ICHD–ENVIRONMENTAL HEALTH DIVISION

Statesville Office (704) 878-5305 | Mooresville Office (704) 660-3625 | PERMIT # AP 307623

SEPTIC IMPROVEMENT PERMIT / AUTHORIZATION TO CONSTRUCT / OPERATION PERMIT / EXISTING SYSTEM

SUBDIVISION: Estates at sundown cove | SECTION: P3S#1 | LOT # 52 | LOT AREA: .57acres | DESIGN FLOW: 480GPD | L.T.A.R.: .3

INITIAL SITE SKETCH

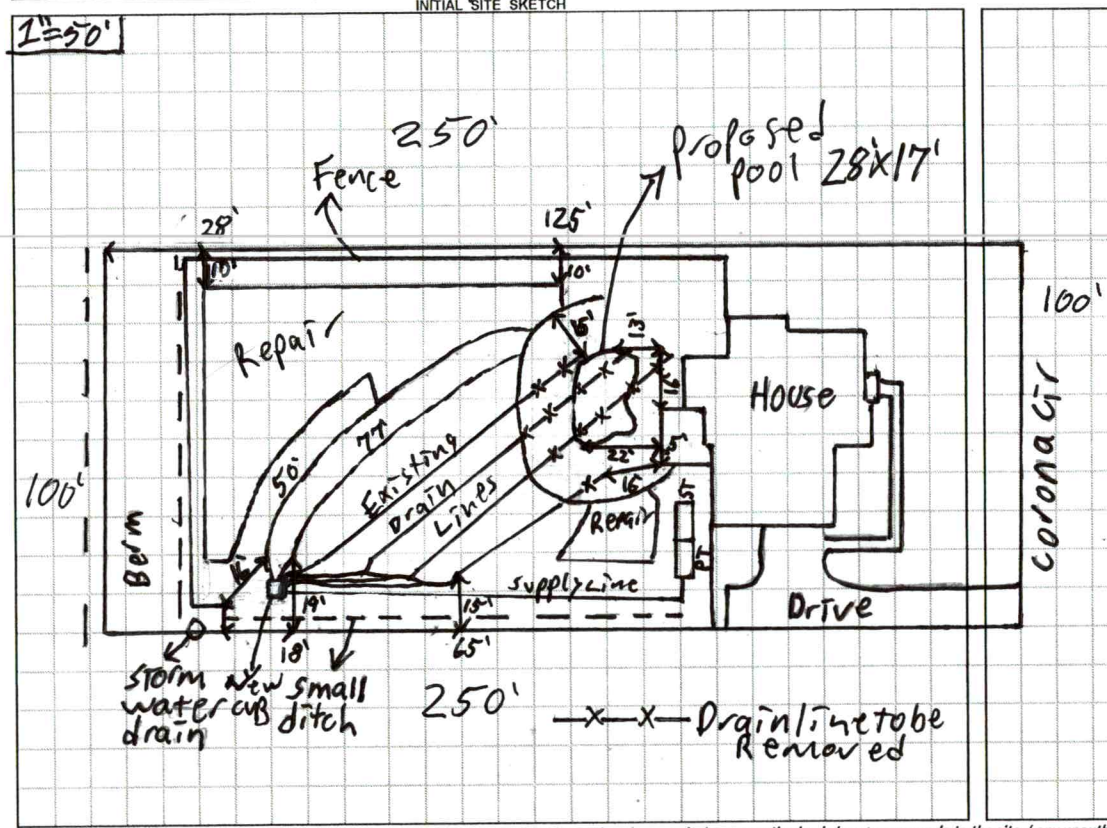
Comments / Conditions: Install 2 new Lines on contour. All sections of existing drainLines that extend through pool and the 15' set back must be properly abandond.

AS BUILT SKETCH

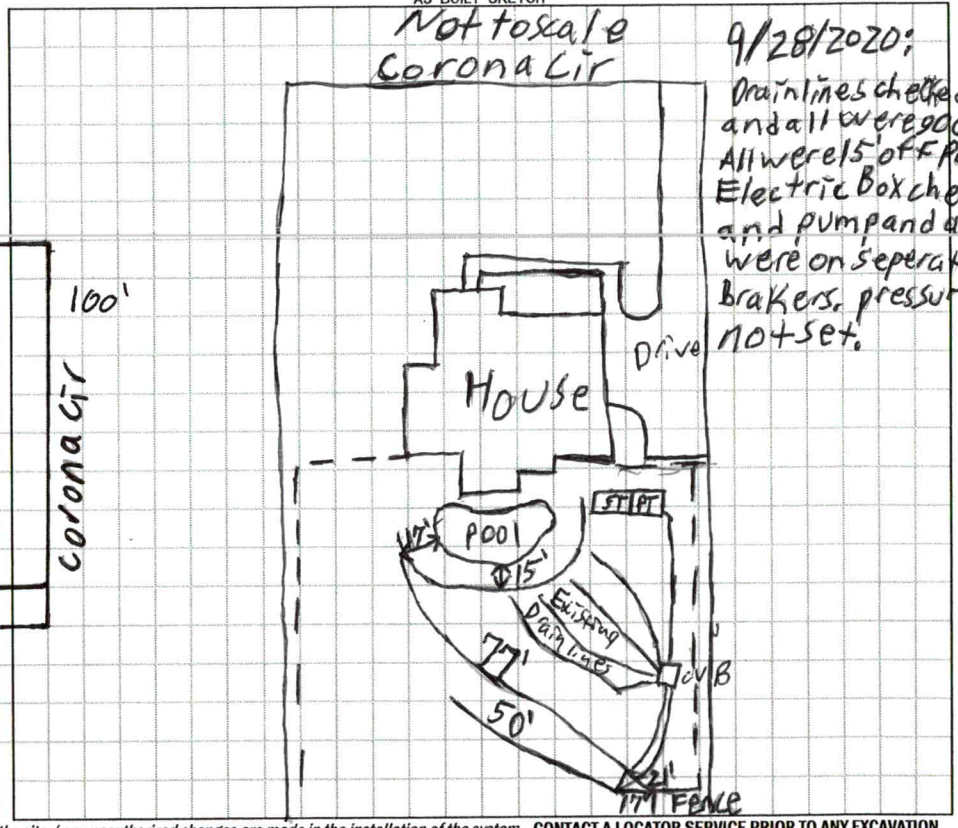
9/28/2020: Drainlines checked and all were good. All were 15' off Pool. Electric Box checked and pump and alarm were on seperate Brakers. pressure not set.
